Friends of Hahamongna

Comments and Concerns Re

Hahamongna Watershed Park Master Plan Addendum and Draft Initial Study

January 8, 2010

Figure F1 HWP Annex Vehicular Road/Trail/Parking Connection, MIG

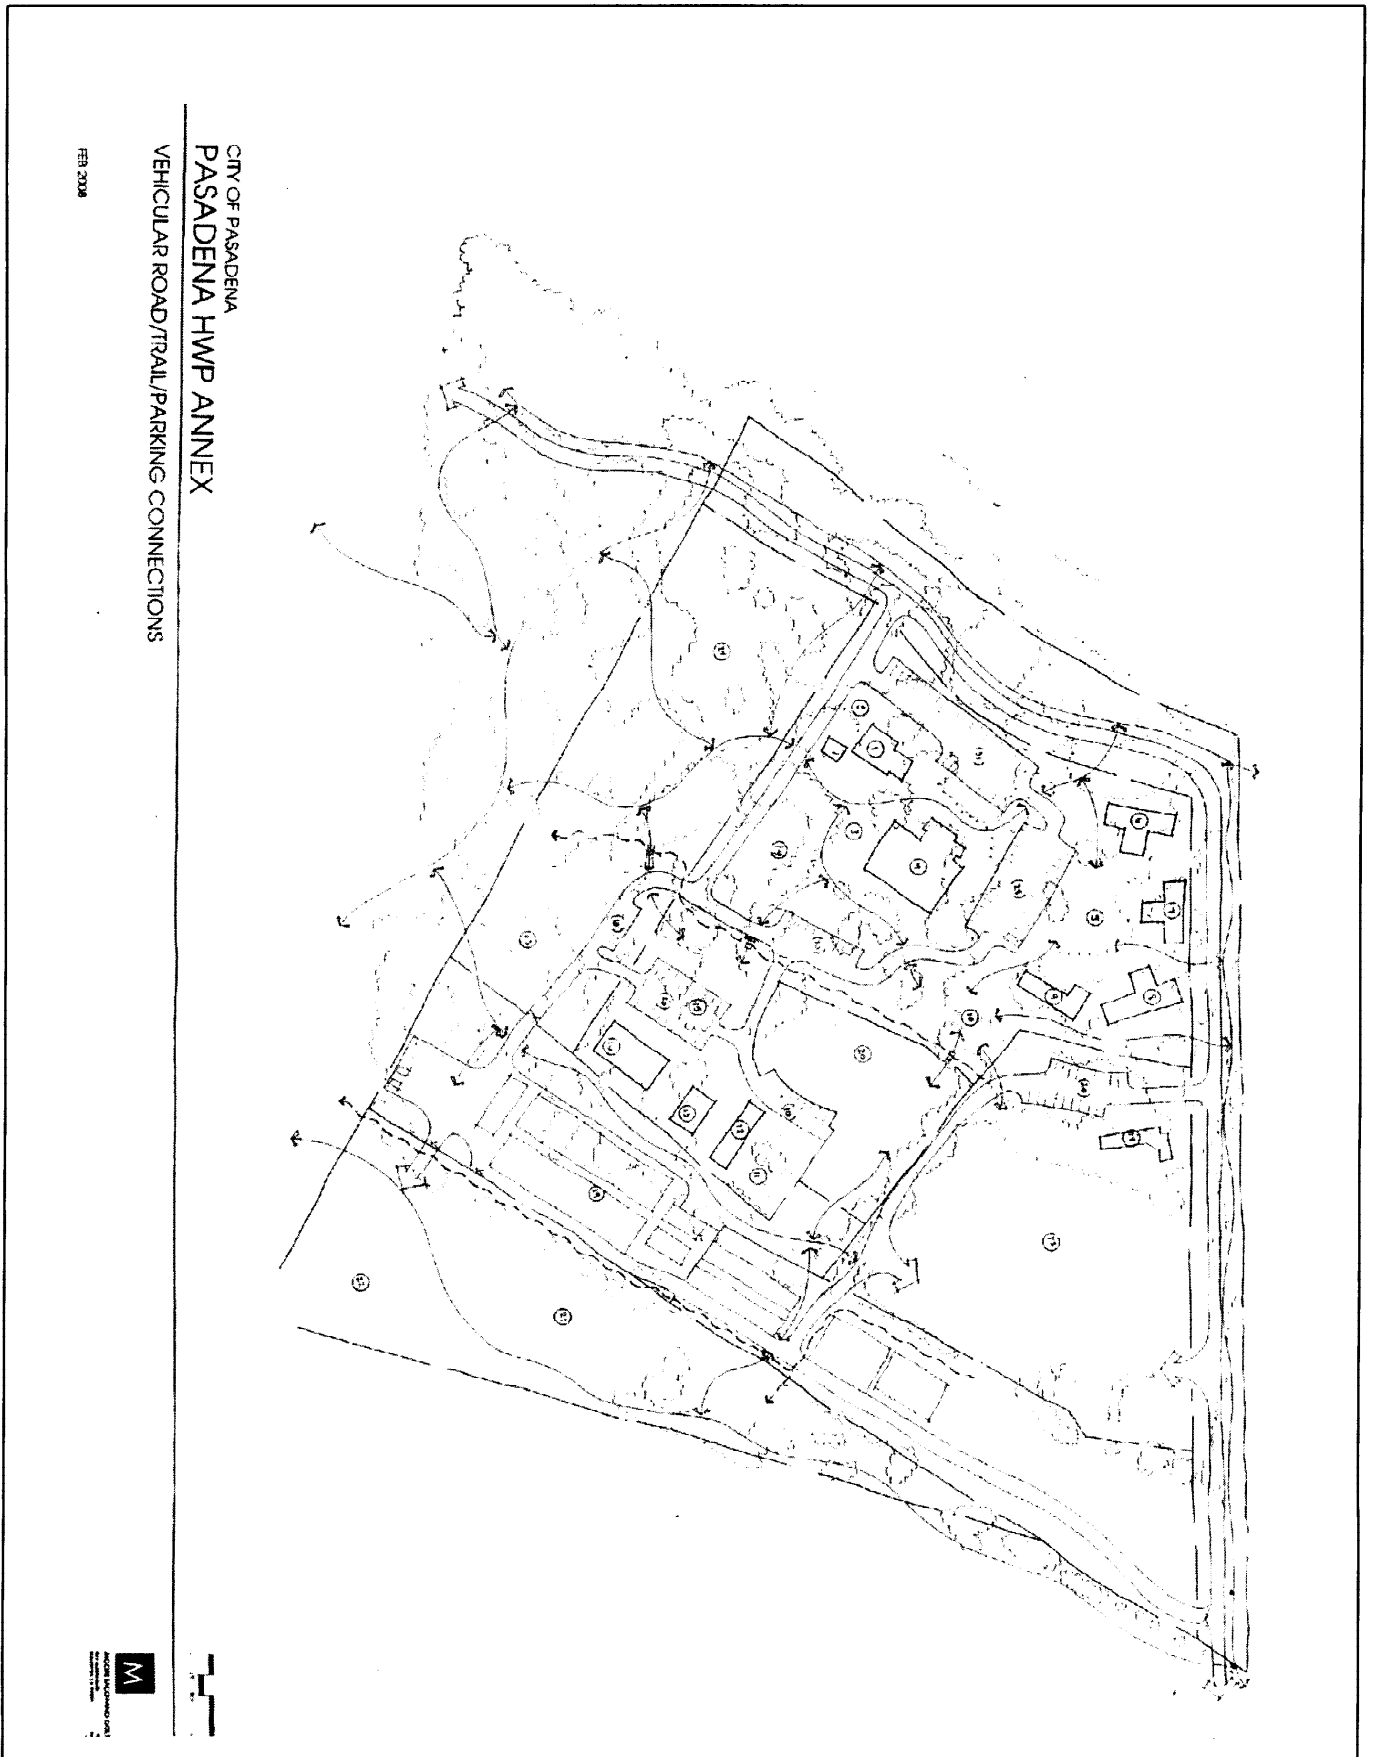
FOH b19 [4. The Annex Plan and Initial Study state that the equestrian boarding and youth camp areas are being realigned to address drainage issues when planning documents show they are being realigned to provide circulation around the property from the formerly proposed road on the Annex (Figure 1).

1. The Annex Plan states that the re-grading and reconfiguring of the horse boarding areas is being done to improve drainage (p. 3-15). **An exhibit prepared by Moore Iacofano Goltsman, Inc during the Annex planning process shows instead that the regrading and reconfiguring of the horse boarding area is actually being done for circulation purposes related to the formerly proposed road (Figure 1).** The February 2008 exhibit, entitled "Vehicular Road/Trail/Parking Connections", shows the road through the northern corridor with an arrow pointing toward the JPL west parking lot. This proposed road is shown as connecting with a realigned access route along the eastern edge of the horse boarding and youth camp areas where stalls are now located. Since the northern road through the corridor has been taken out of the plan, however, there is no longer any project in the plan that requires this expensive infrastructure relocation.

Figure F2 Shade canopy along the existing Annex trail

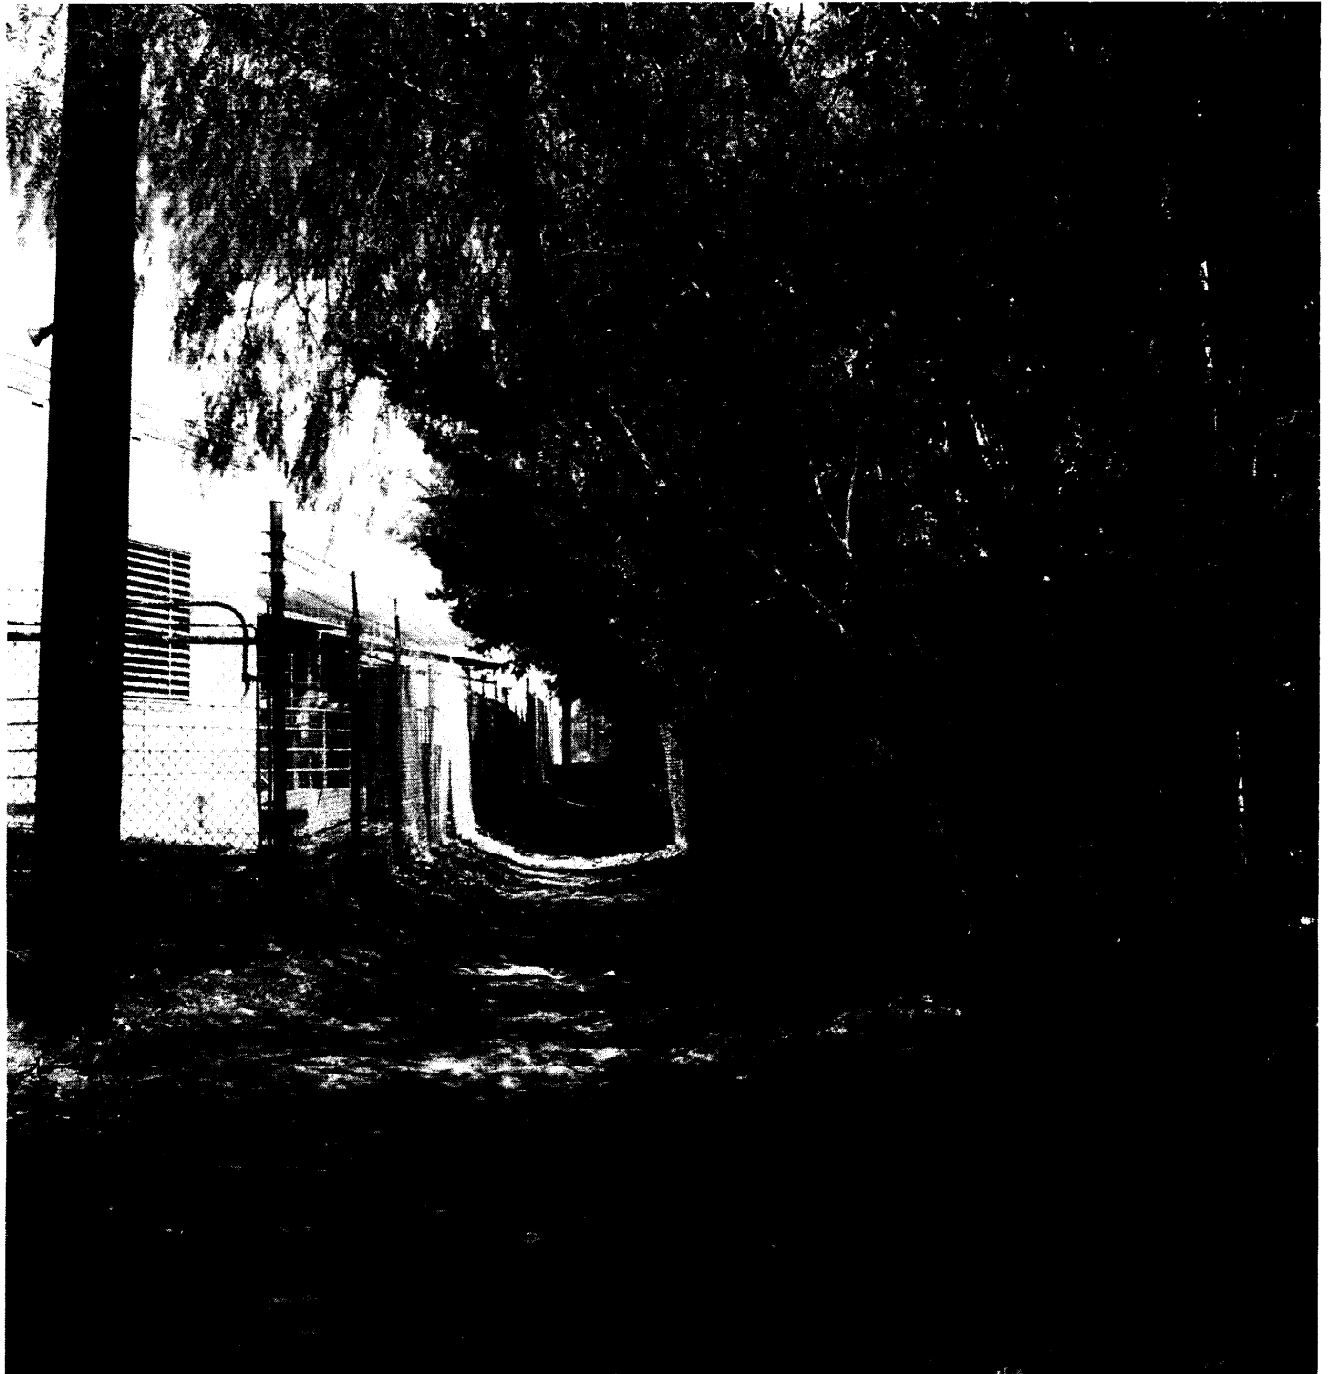
The removal of 70 non-native trees will have a major impact upon aesthetics on the Annex. The removal of these trees would substantially degrade the visual quality of the Annex since many of these are mature shade trees which have been growing for decades and provide shade and beauty (Figure F2). They include liquid ambers, Chinese elms, eucalyptus, pine, California peppers, Italian stone pines, and other species. The many visitors to the Annex greatly enjoy the beauty of these trees, the shade they provide, and the wildlife they support.

Star News 3-29-53

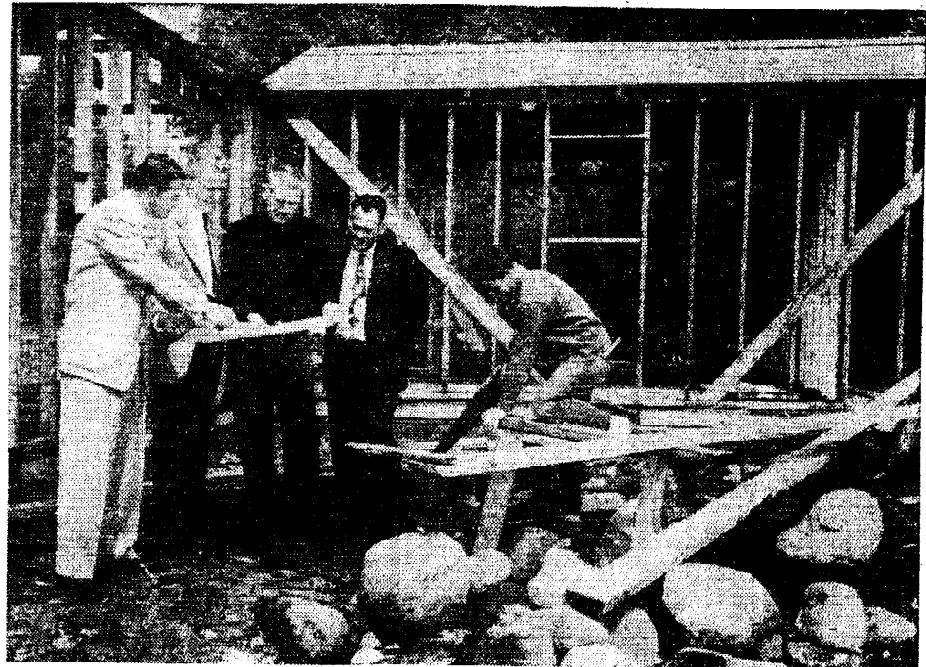
- In the Buildings and Amenities section, the Annex Plan neglects to mention that the Rose Bowl Riders clubhouse was built even earlier than the Forest Service buildings. The City of Pasadena donated two obsolete buildings which members of Rose Bowl Riders renovated and rebuilt on the property in 1952 – 1953 Figure F7 “[Pasadena Officials] Approve Project” Pasadena Star News, March 29, 1953.

Figure F11 Shared use trail at the south end of Hahamongna

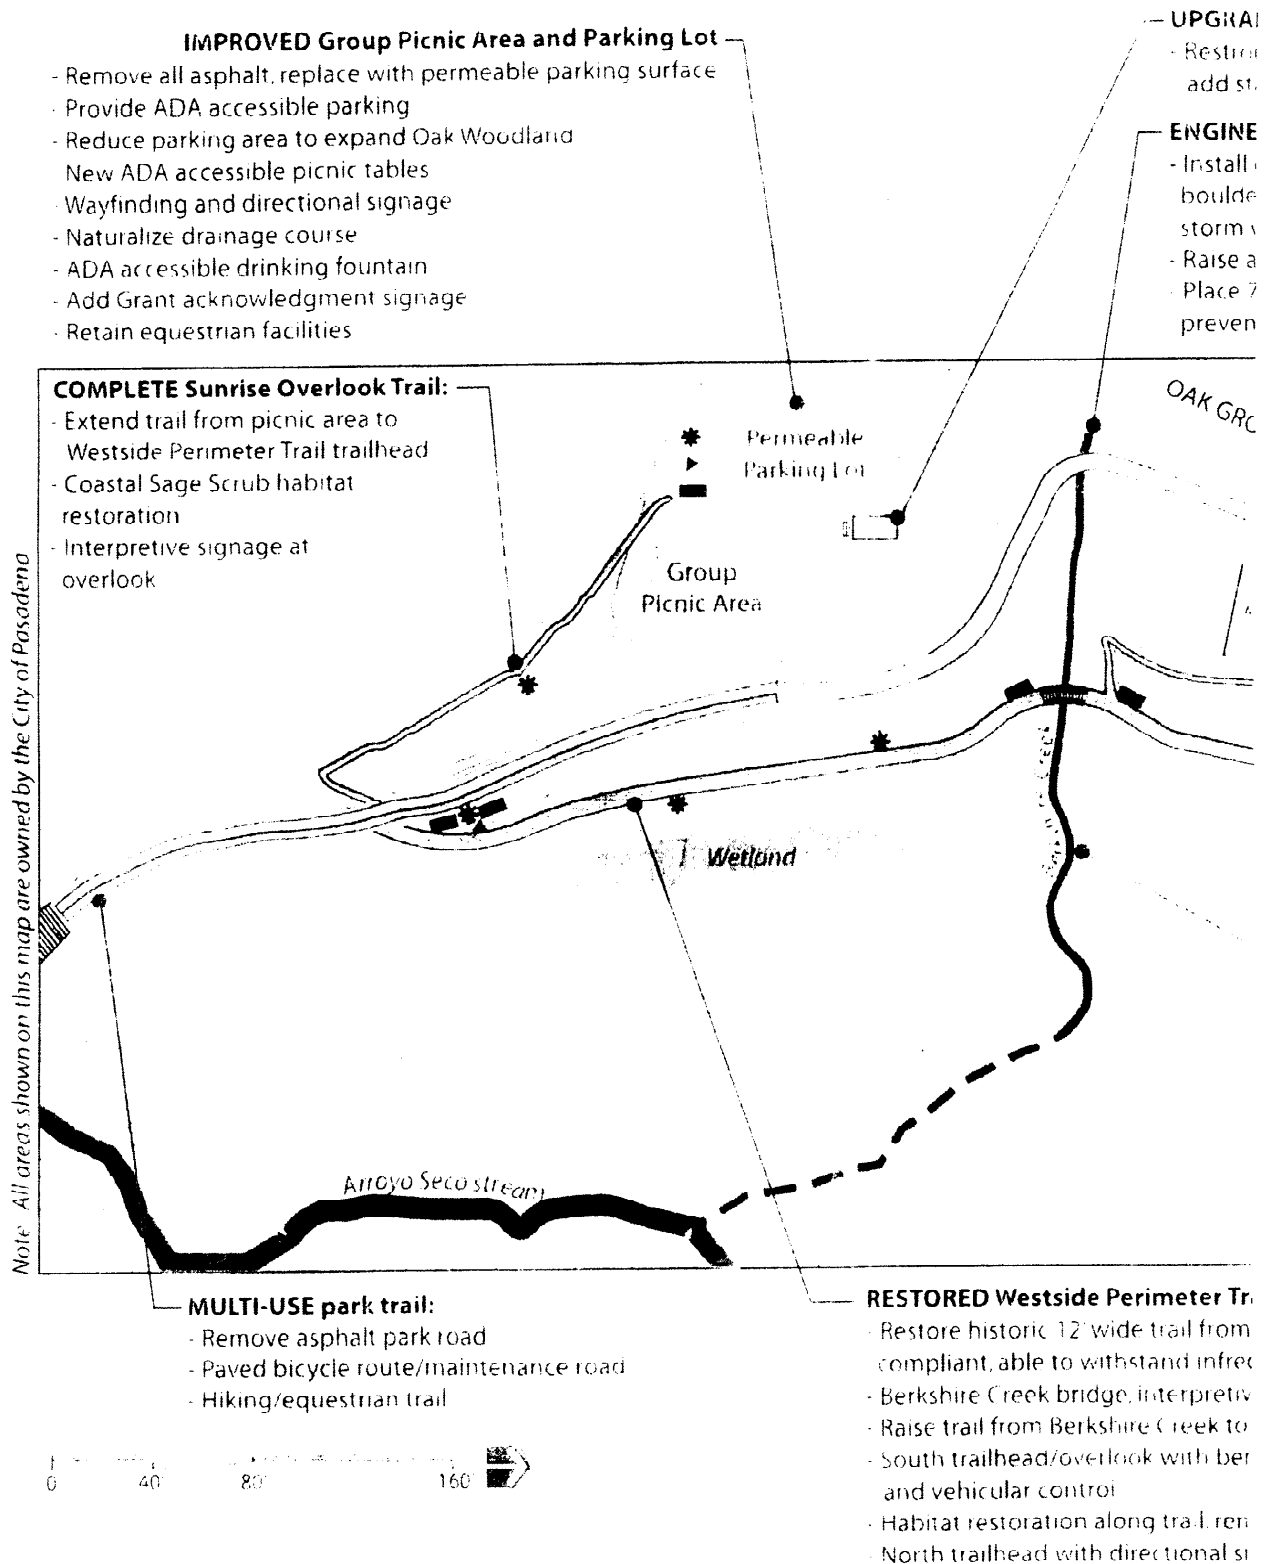
There is no other bikeway location within Hahamongna where bicyclists are not immediately adjacent to other users nor is there any other location where a divider is called for. In the southern end of the park in the vicinity of the Devil’s Gate Dam and the Flint Wash Bridge all users groups travel together for over 1250 feet with no dividers or buffers of any kind. This is 450 feet longer than the segment on the Annex. On the approaches to the bridge they share a 12 ft wide asphalt bikeway with a four ft wide dirt shoulder (Figure 11). The bridge itself is only 12 ft wide. For 560 ft, the corridor is no wider than 16 ft.
